Service Bulletin

Bulletin No.: 20-NA-198

Subject: Trailer Running Lights Shut Off Due to Excessive Load on the Running Lamp Circuit

5209978

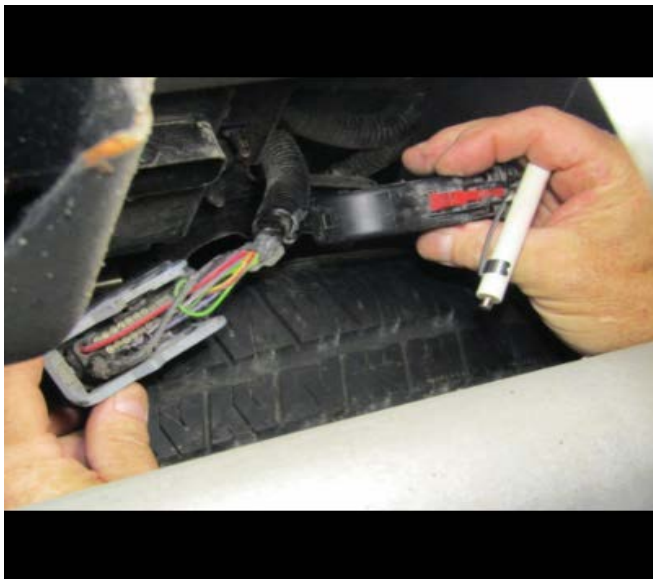
3. Locate the Trailer Lamp Control Module (2) and disconnect the chassis harness X1 electrical connector.

5652576

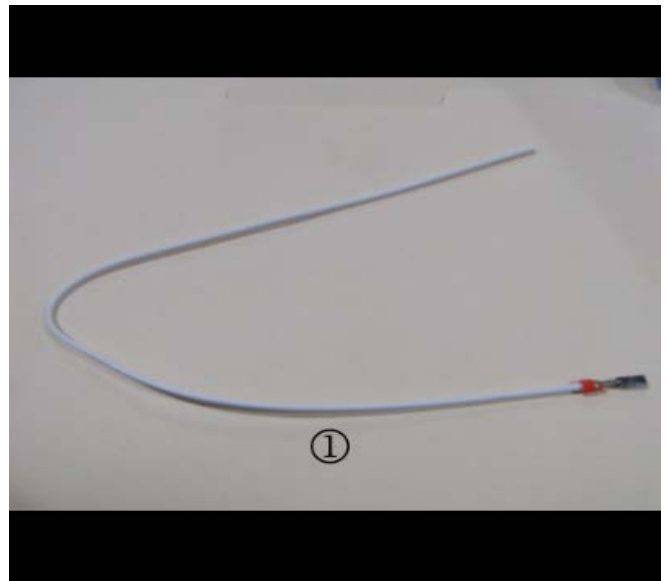
6. Locate the Gray/Brown wire, at pointer (1), connected to cavity 5, and cut the wire approximately 7.62 cm (3.0 in) from the connector body. The wire will be re-located to cavity 25 (2).

5662018

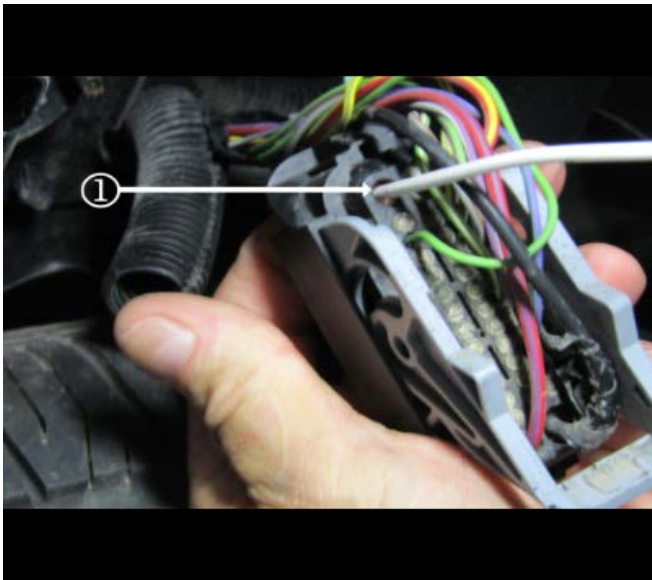
8. Remove the seal from connector cavity 25 and install the new terminated lead (1) into this cavity. Ensure the terminal locks into place by pulling back gently on the wire.
